DATE: AUGUST 24, 2026

ADDENDUM NO.: 2

PROJECT: A NEW BRANCH OFFICE
1208 Texas Research Parkway (SH211)
[211 and Potranco]
(Bexar County)
San Antonio, Texas 78245

SSI – 1 (Addendum-2)

A2.0

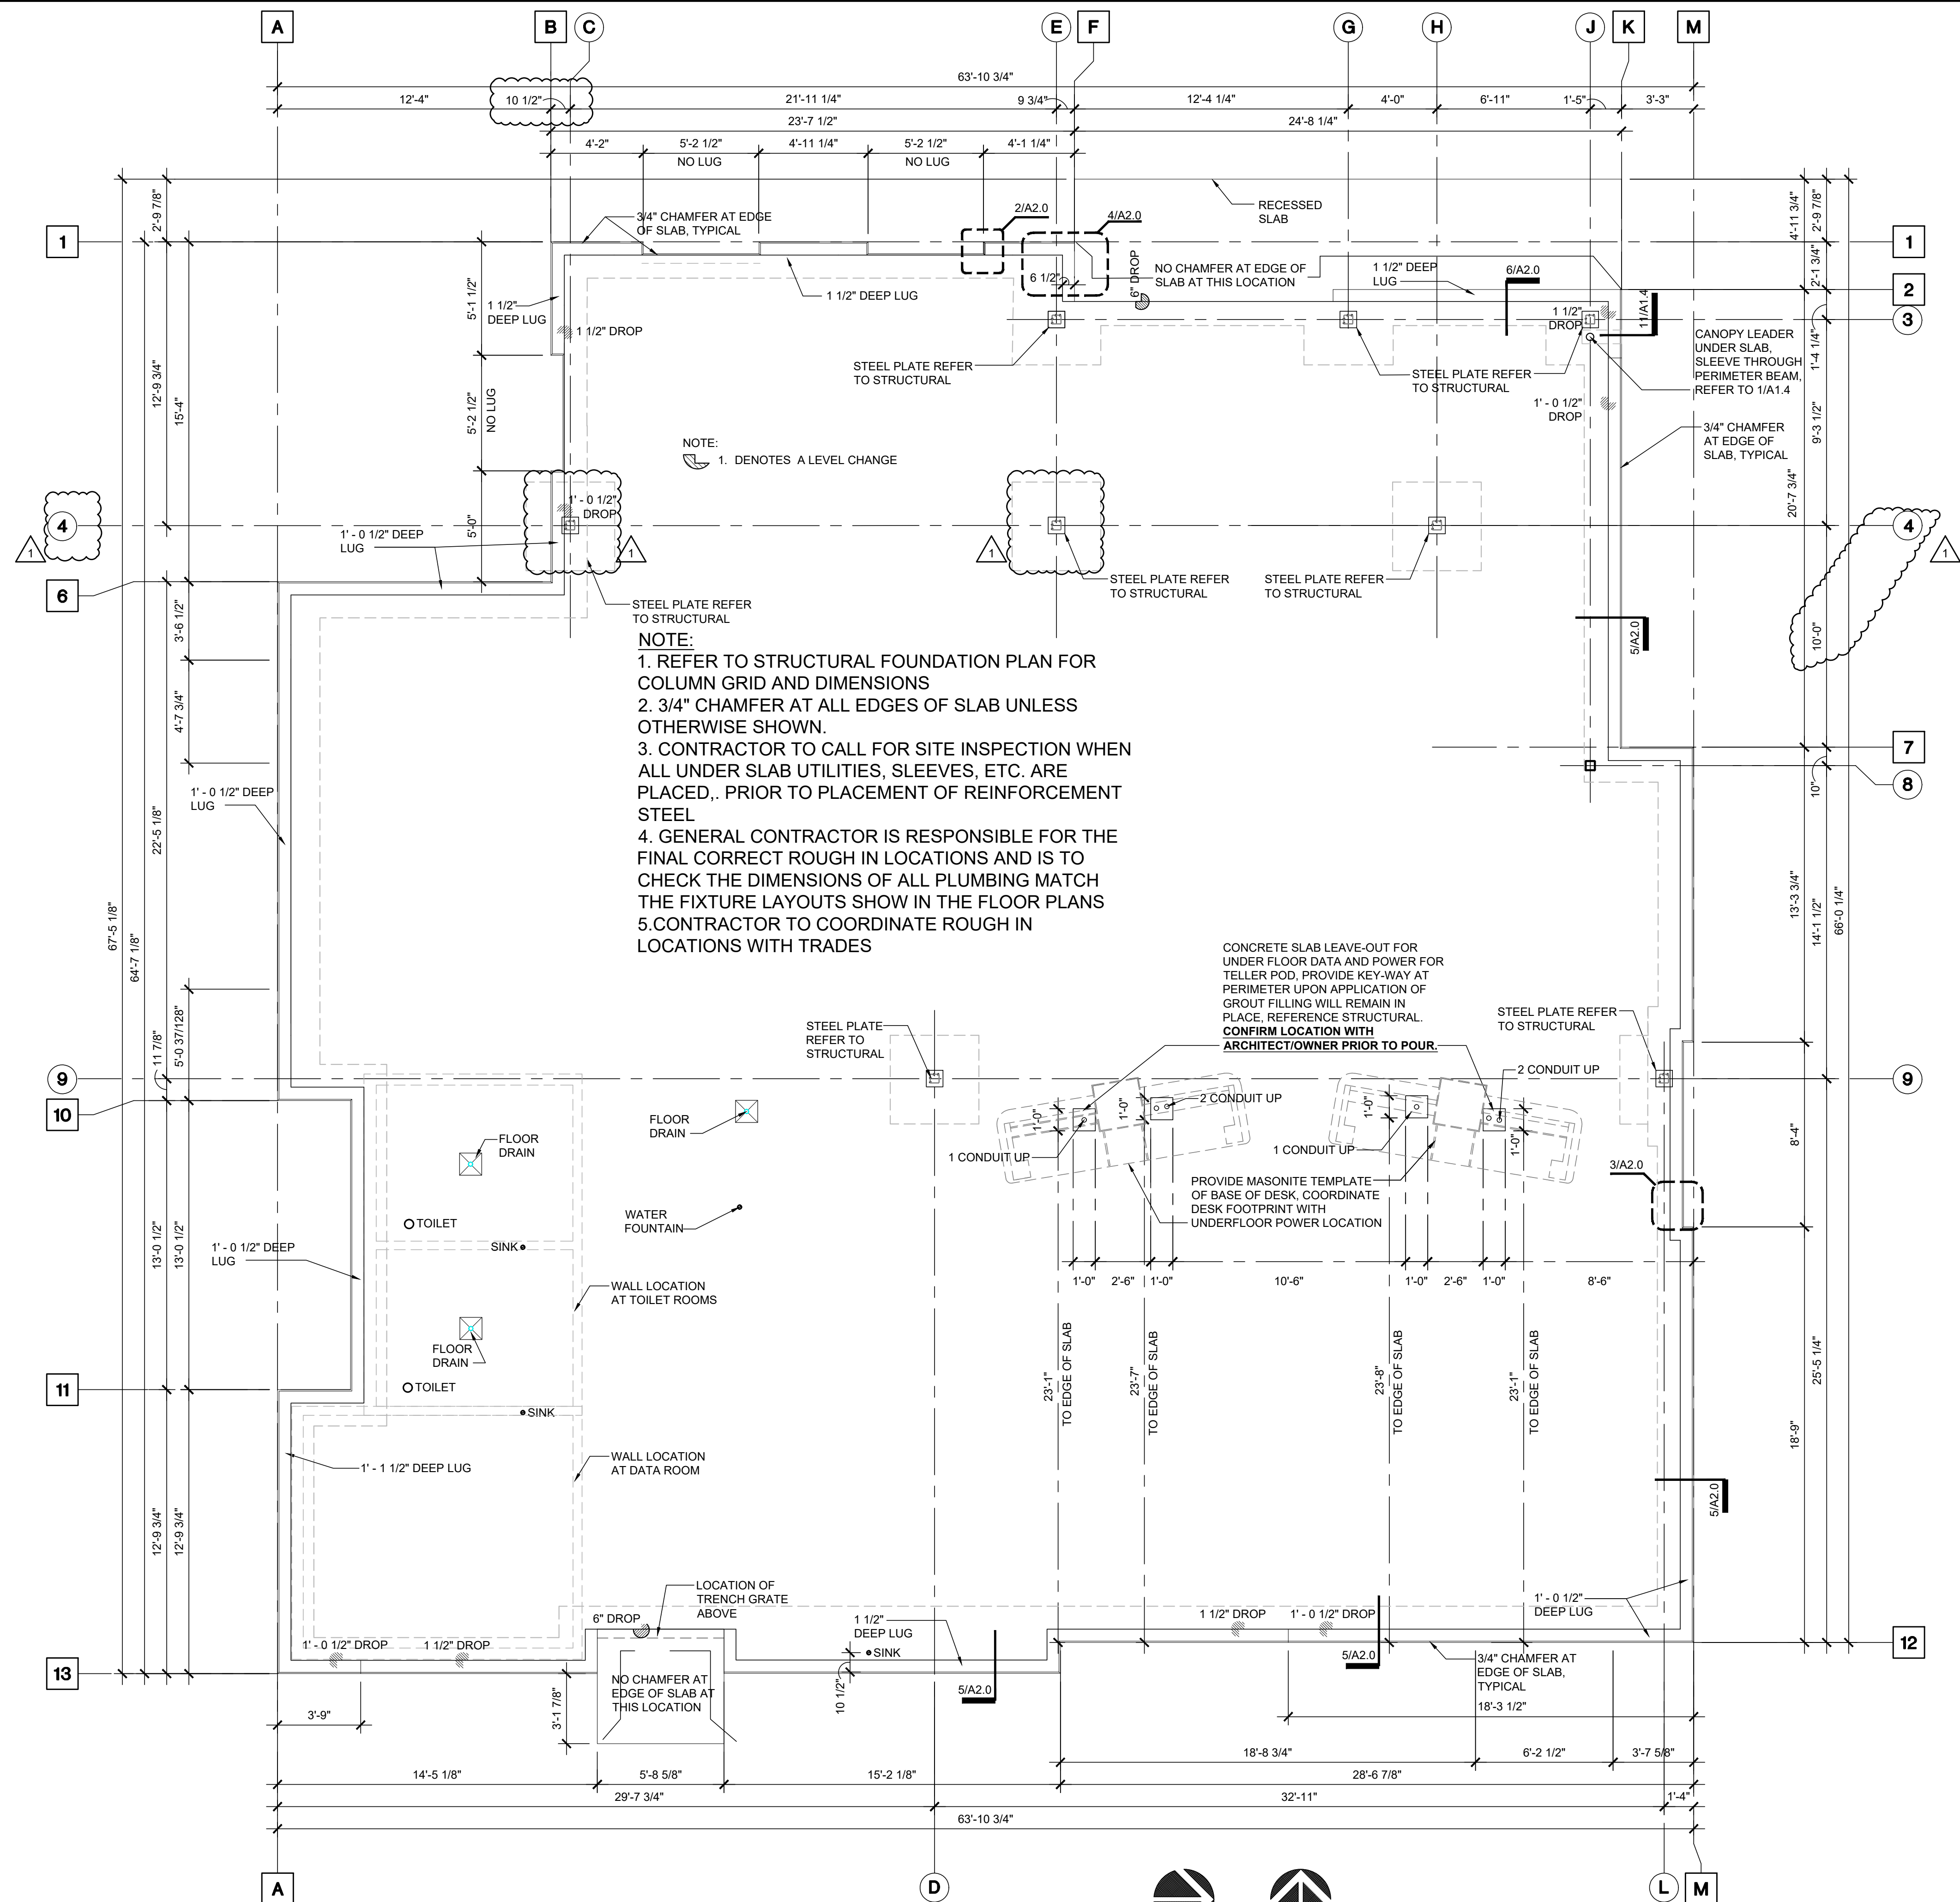
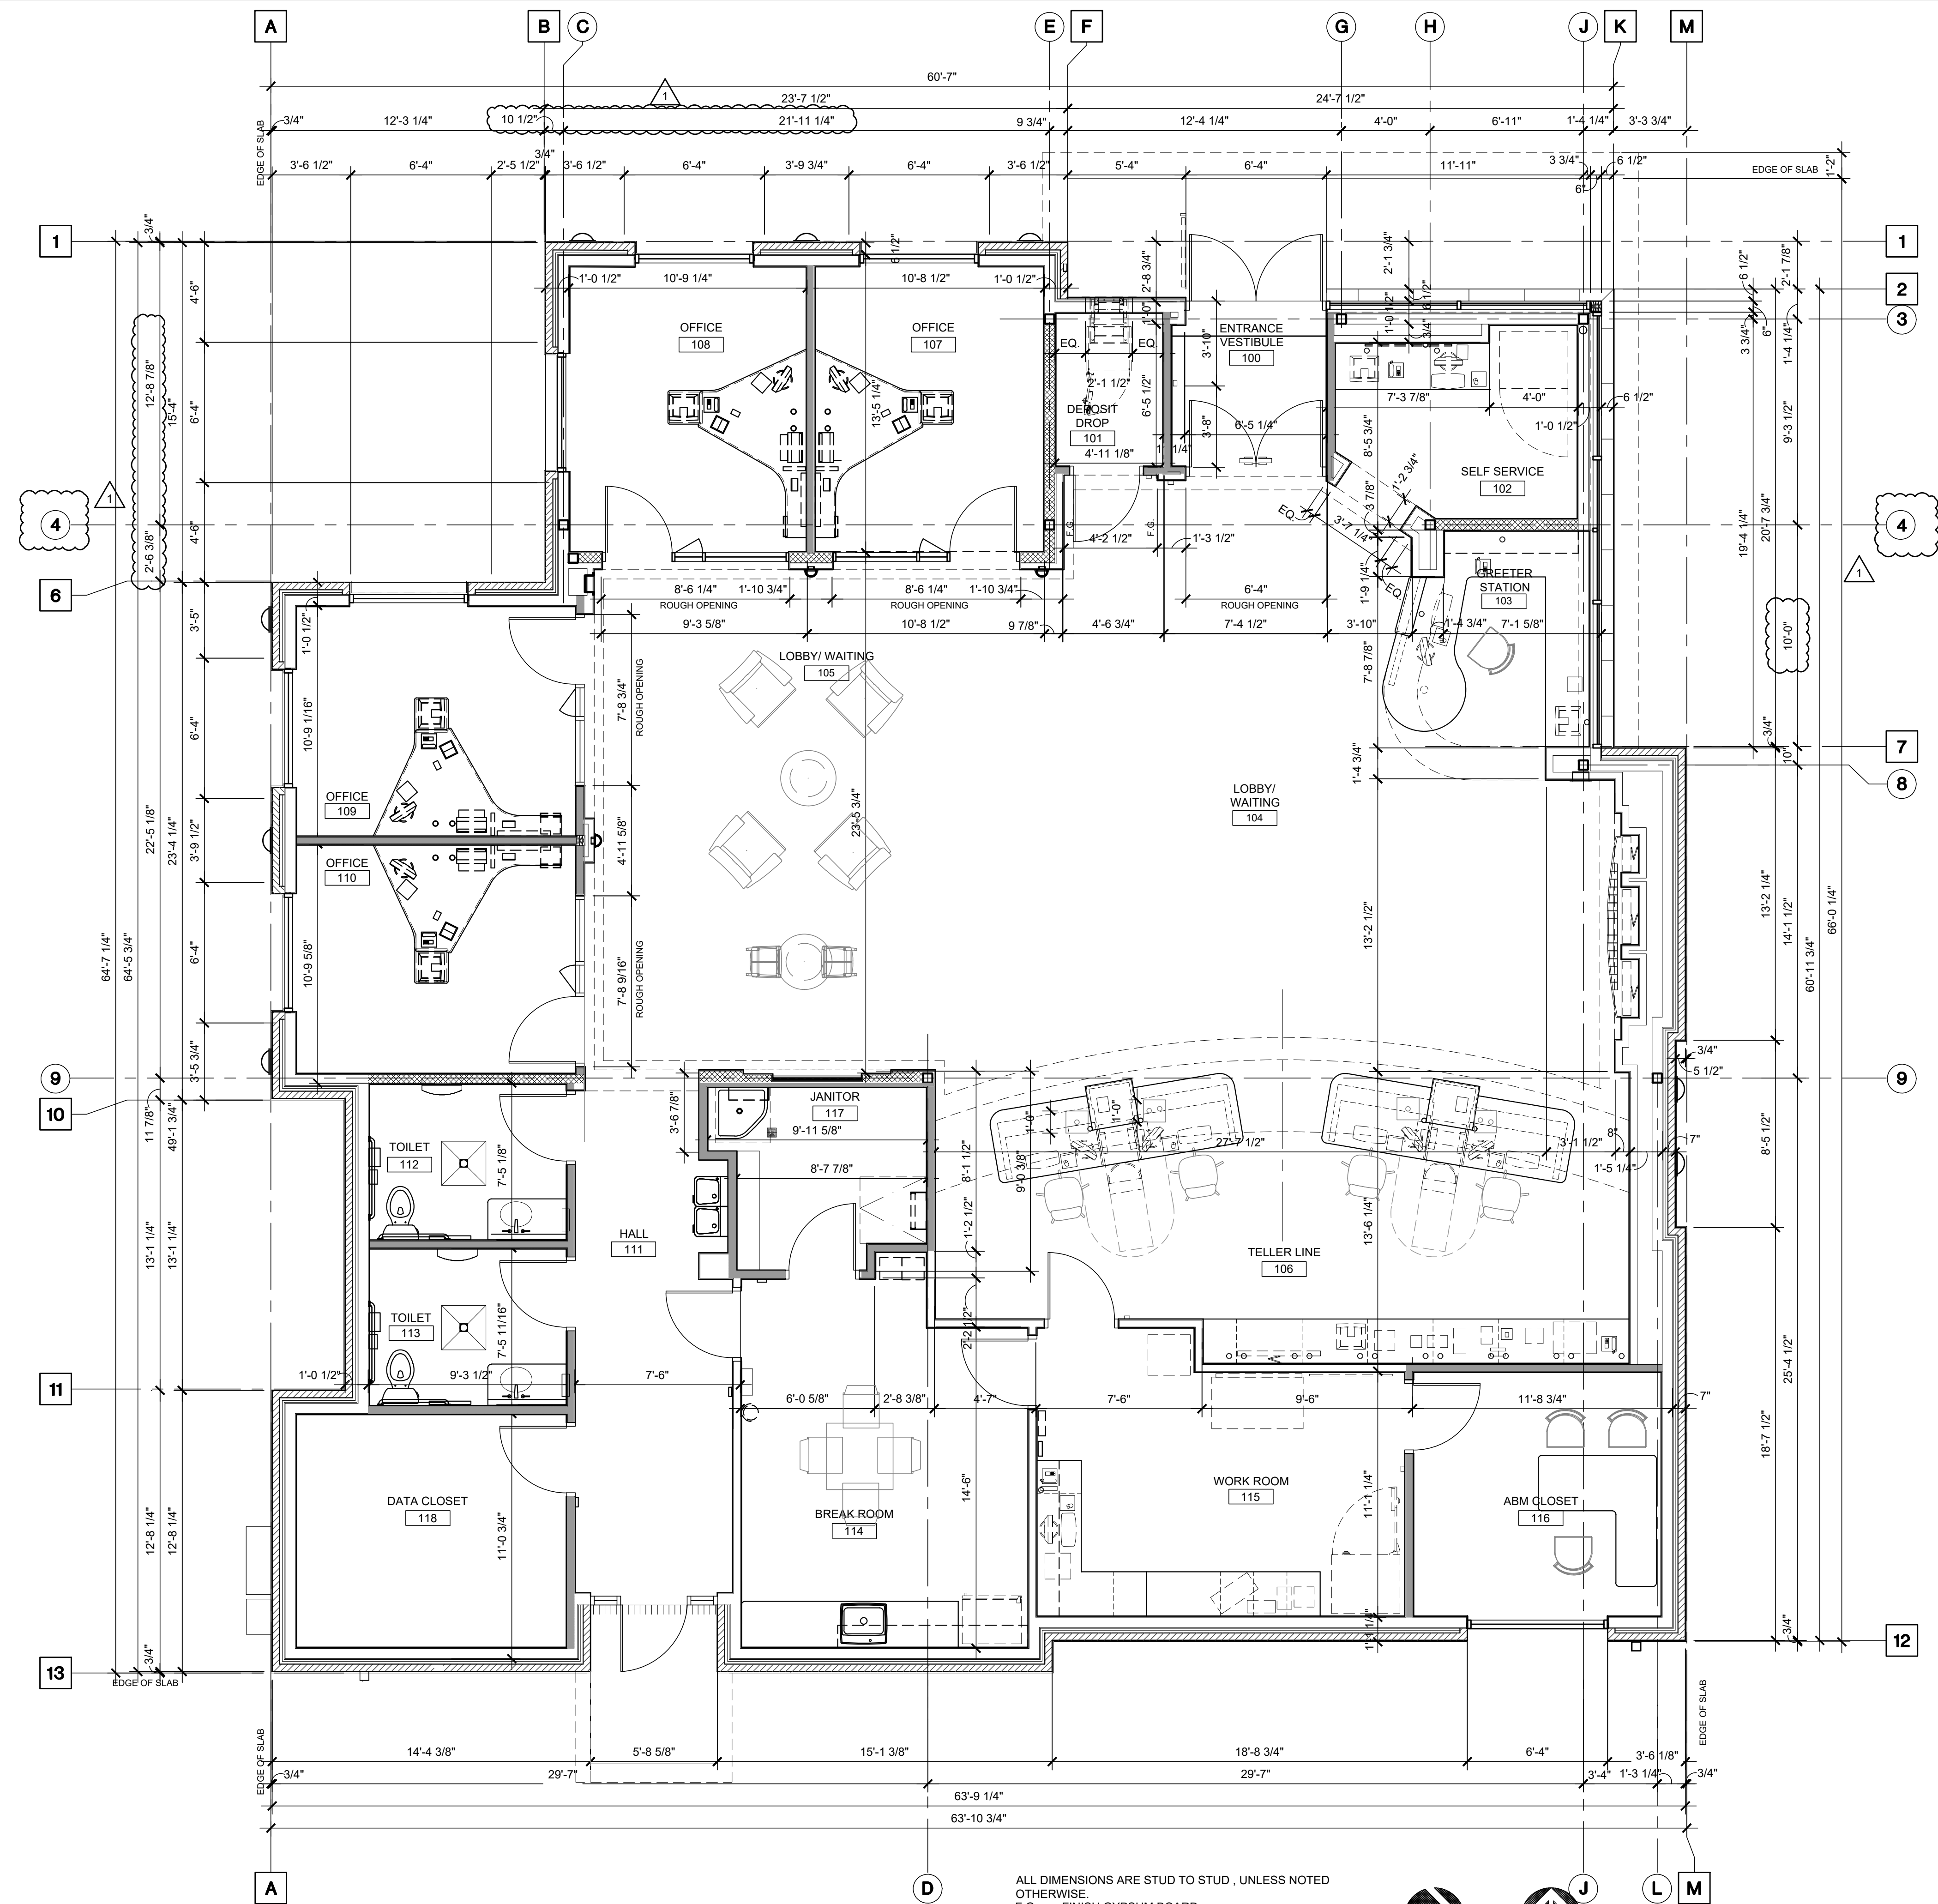
Sheet A2.0 - Omitted grid line 5. Revised columns C5 and E5 to C4 and E4. Corrected dimensions

A6.1

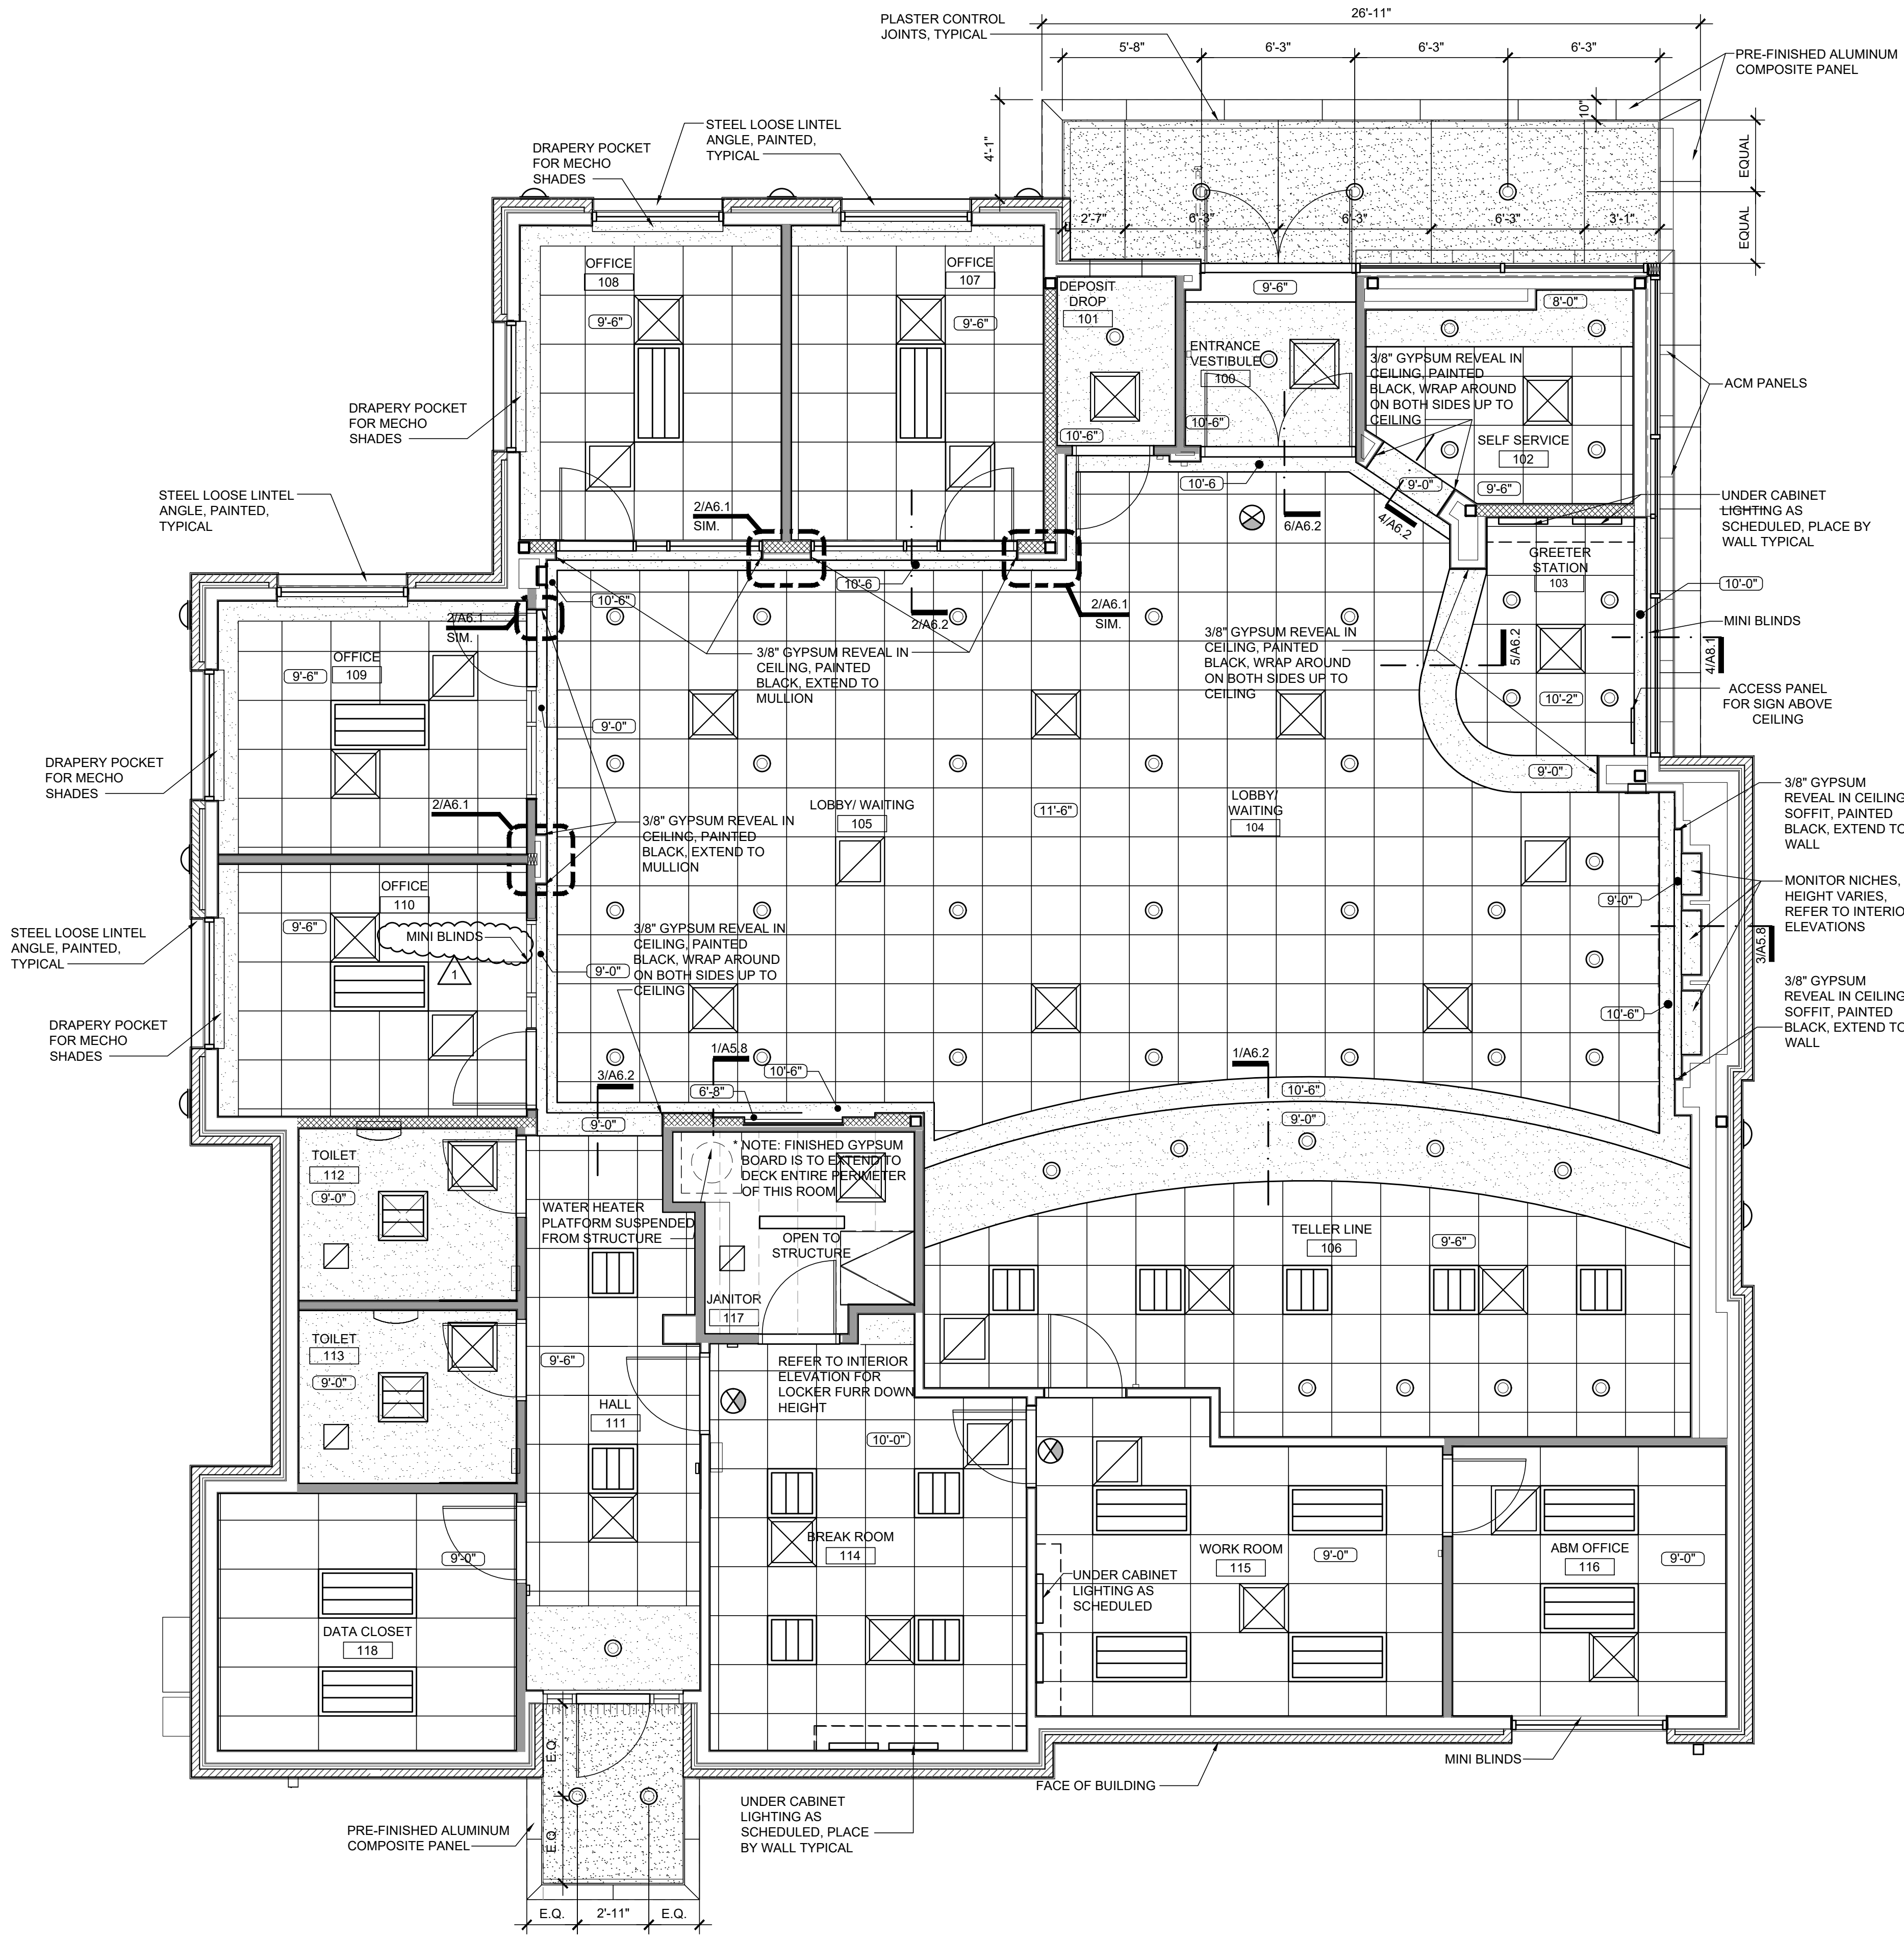
QUESTION: 10.03 Note 401 Equipment note for Mini Blinds is shown at Office 110 interior window. Is this the only interior window receiving Mini Blinds? Or should they be included at Offices 107-109 as well? No interior Mini Blinds are shown on A6.1 either.

Sheet A6.1 – Added note for mini blinds in office 116

ANSWER: Office 110 is the only interior window to receive mini blinds. Mini blinds are also to be installed at office 116 exterior window and greeter station window. Refer to equipment plan for location of roller shades on office exterior windows. See Exhibit A for Clouded revision on A6.1 and A10.3.
